DEVIATION REQUEST AND DECISION FORM

Project Name : The Gardens at North Carefree
 Schedule No.(s) : 5329400012
 Legal Description : TR IN E2 SEC 29-13-65 DESC AS FOLS: COM AT NE COR OF SD SEC, TH S 89<10'57" W 2105.32 FT, S 04<23'18" W 3857.57 FT TO POB, TH CONT ON SD LN 1455.87 FT, N 89<10'38" E 1240.25 FT, N 00<02'55" E 1451.73 FT, S 89<18'20" W 1391.65 FT TO POB, EX PT PLATTED TO N CAREFREE CIR, EX THAT PT CONV BY REC #206084137

A deviation from the standards of or in Section D.3 Pavement Design Criteria of the Engineering Criteria Manual (ECM) is requested.

Figure 1

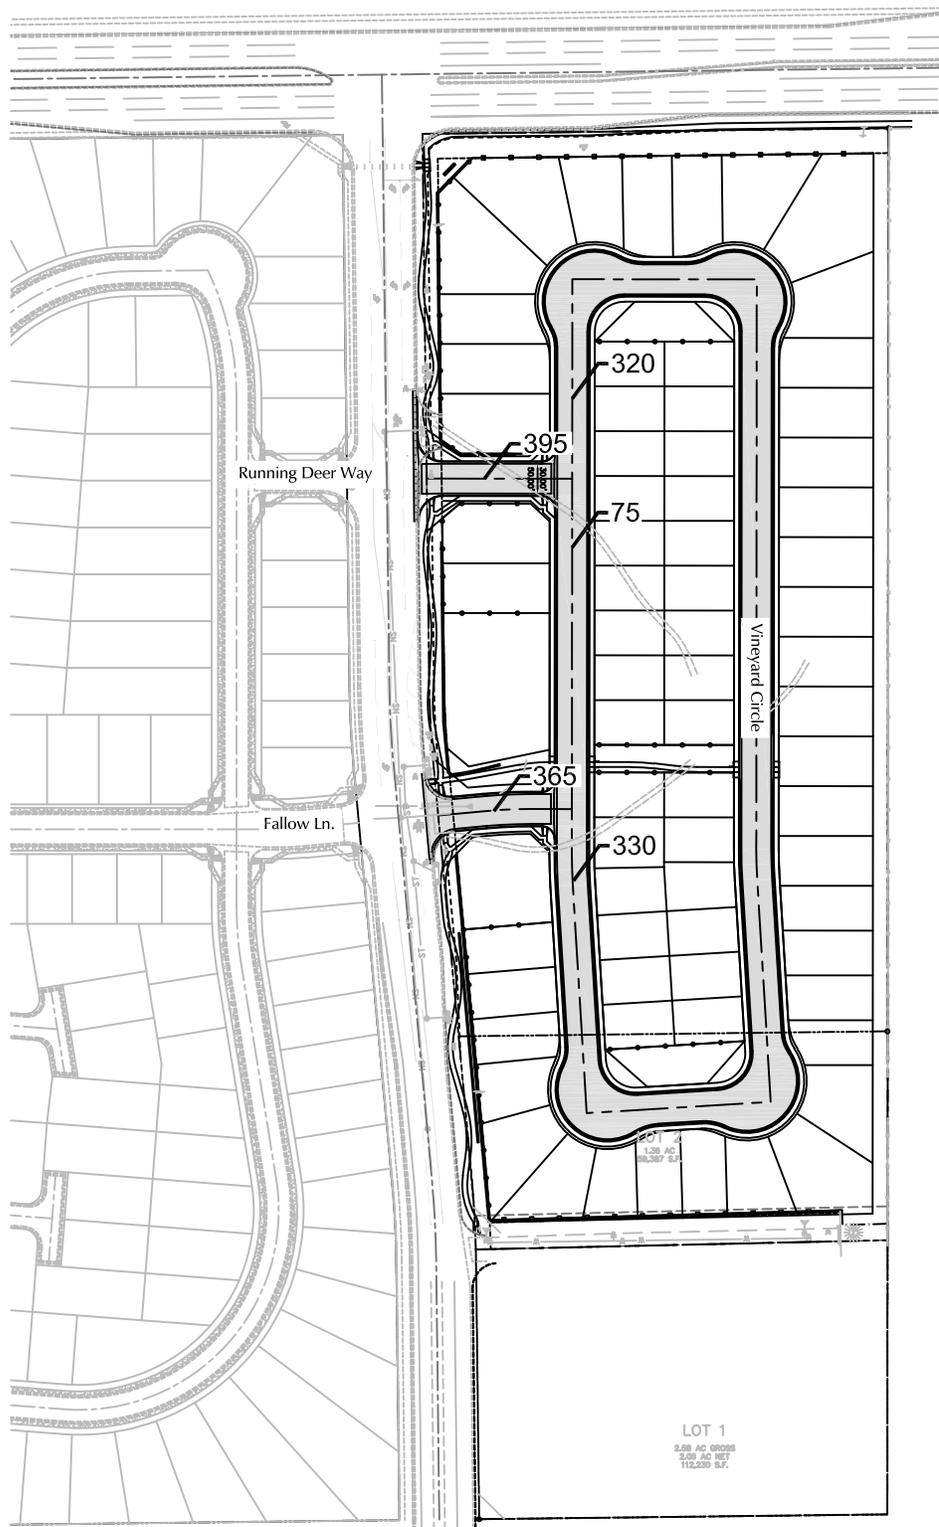
Allow use of ESAL values based on intermediate ADT ranges within the broader Urban Local ADT range (300-3,000 vehicles per day), which result in modified pavement cross sections for all streets within the Gardens at North Carefree (Fallow Lane, Running Deer Way and Vineyard Circle). The resulting recommended design ESAL for these streets, based on this methodology, is 109,500 per the submitted memo dated April 1, 2020. The memo is attached. The memo includes an exhibit showing the subdivision street names.

The previous table D-2 was removed from the ECM, and is no longer acceptable to be used. The proposed ADT on this road network is too high to allow for a reduced pavement cross section from the minimums shown in the current ECM. Comments have been provided in the proposed pavement design reflecting the disapproval of this requested deviation.
